Applicant : Jun Koyama  
Serial No. : 09/912,596  
Filed : July 26, 2001  
Page : 11 of 13

Attorney's Document No.: 12732-056001 / US5129

Amendments to the Drawings:

Fig. 14  
Prior Art

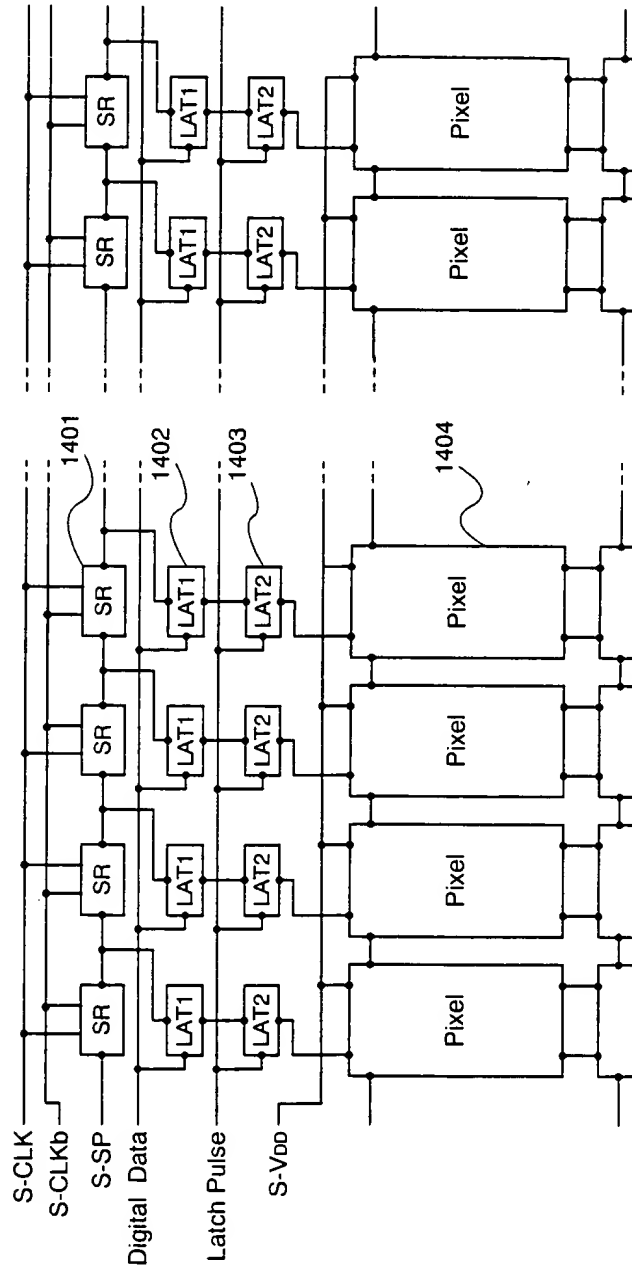
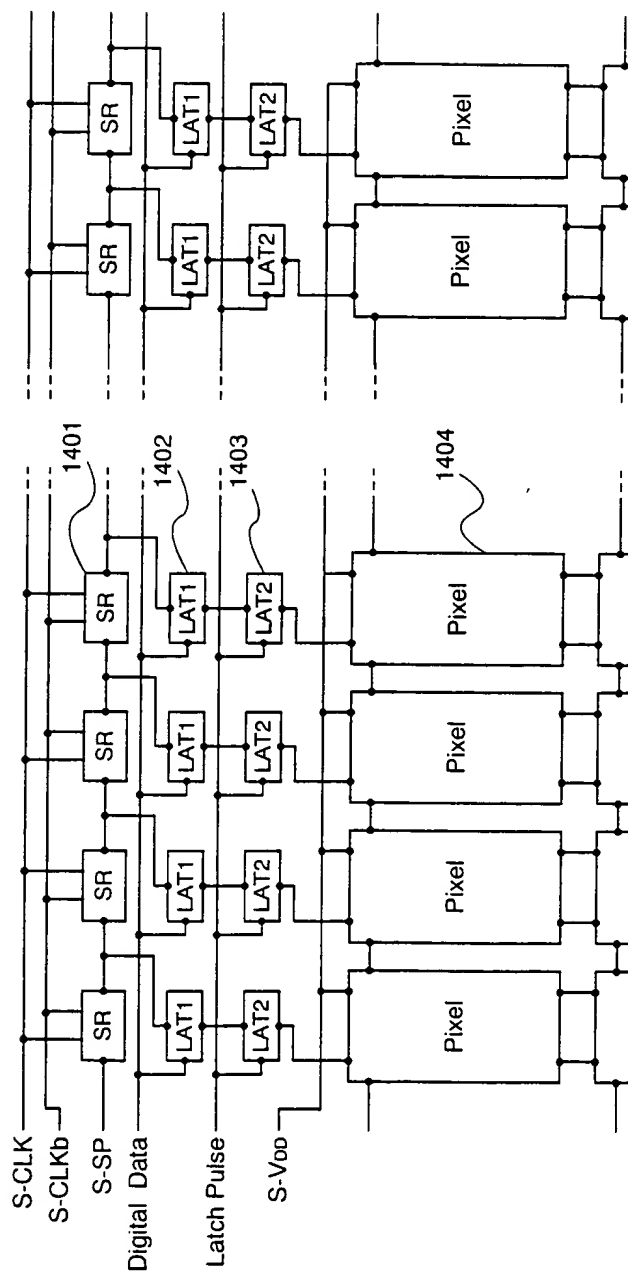
In Figs. 13, 14, 19A, 19B, 20A, 20B, 20C, and 20D, add the legend "Prior Art".
